**SUBSURFACE SEWAGE TREATMENT SYSTEM INSPECTION FORM
AITKIN COUNTY, MINNESOTA**

Township Farm Island Date of Inspection 5/27/2020 I App. Number 44842
10/19/2020 F 2020-5425
 Owner Leron + Lillian Farrar Parcel Number 07-0-046110
 Project Address 41329 300th Ln. Installer Mark Ritter
 City Aitkin Zip Code 56431 TI 3BR 7B

**A STRUCTURAL ENGINEERING REPORT ON THE PROPOSED NEW
SEPTIC SYSTEM ADDITION TO THE FARRAR'S SPIRIT LAKE PROPERTY.**

Site Drawing

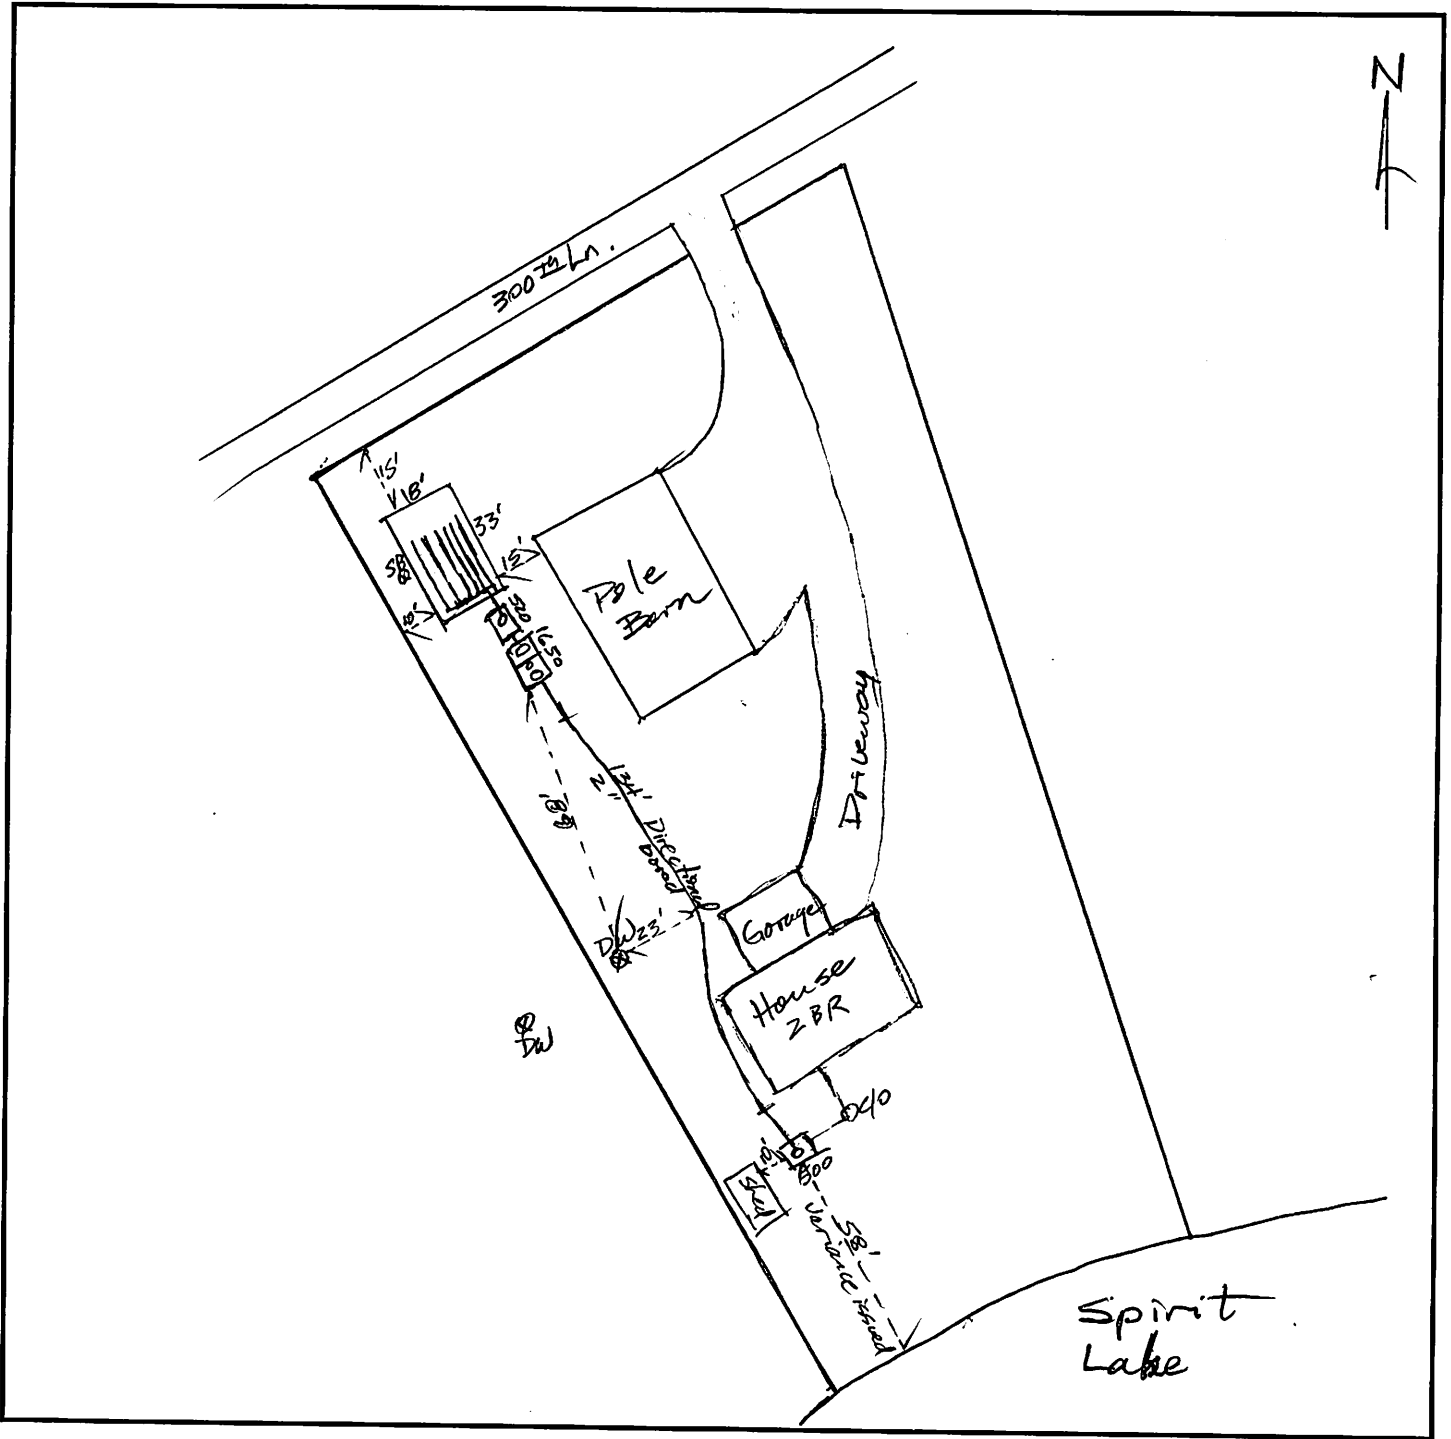
Inspector's Comments: 15' sb of df to pole shed covered by engineers report. Variance issued for tank sb to Spirit Lake
Gould WEOS11 1/2 HP pump used in 540 G. Infiltrator
